# **Protective Relaying Philosophy and Design Guidelines**

## **PJM Relay Subcommittee**

~~August 15, 2013~~ April June XX, 2018

**Figure F-5B Reactance Relay Characteristics with Maximum Bulge Point in Zone 2 Area**

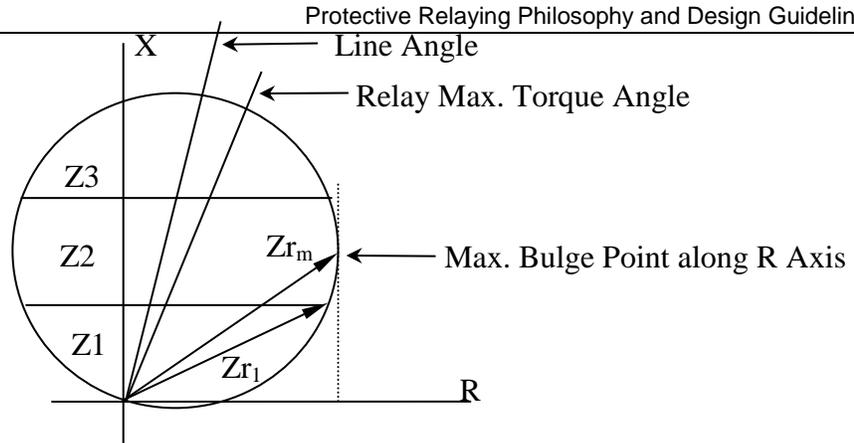
DRTLL ~~must~~ should be computed for Zones 1 and 2 only  
 Using  $Z_r = Z_{r1}$ , &  $Z_{rm}$  with corresponding Kt time delay factors for each Zone

**Figure F-5C Reactance Relay Characteristics with Maximum Bulge Point in Zone 1 Area**

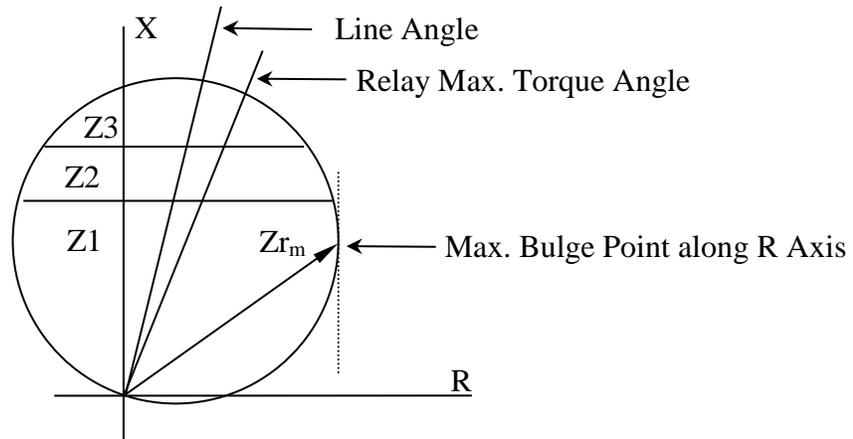
DRTLL ~~must~~ should be computed for Zone 1 only  
 Using  $Z_r = Z_{rm}$  with corresponding Kt time delay factor for Zone 1
